REPLACEMENT OF WHITMAN GENERAL VACUUM SWITCHES MODEL P118V-IN-K4L-2, AND P118V-IN-K5L-1 OR/AND U.M.A. VACUUM GAGE MODEL 3-200-3 WITH EDO-AIRE SWITCH P/N 22-1280-04

M20J S/N 24-0084, 24-0378 thru 24-0447

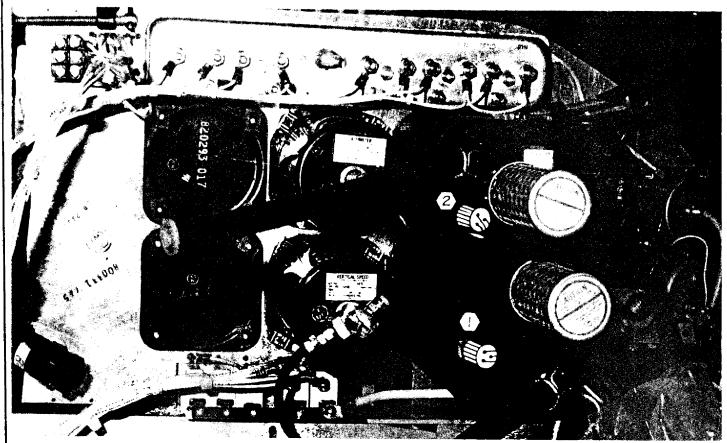
-Remove Whitman General vacuum switches, clamps, hose, etc.

- 1 Install Edo-Aire vacuum switch.
- Alternate installation.
